# **Final Environmental Impact Statement**

## **Cottage Hill Landings**

Proposed Action: Cottage Hill Landings Residential Development

## 2.0 RESPONSE TO COMMENTS

**Re: Supplemental EIS: Cottage Hill Landings**

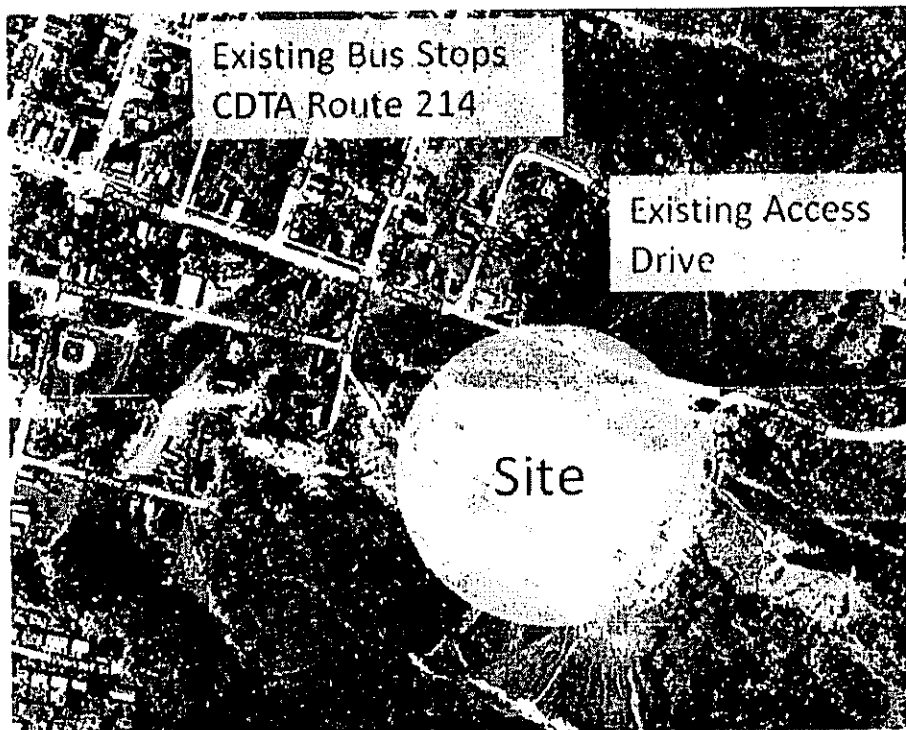
The Capital District Transportation Authority (CDTA) provides public transportation services for the Capital Region. Under the State Environmental Quality Act (SEQRA), we are an interested agency for site review and environmental clearance for the above-referenced project because it impacts our transit service. CDTA's Route #214 has its closest stop at 3<sup>rd</sup> and Partition Streets (see graphic below).
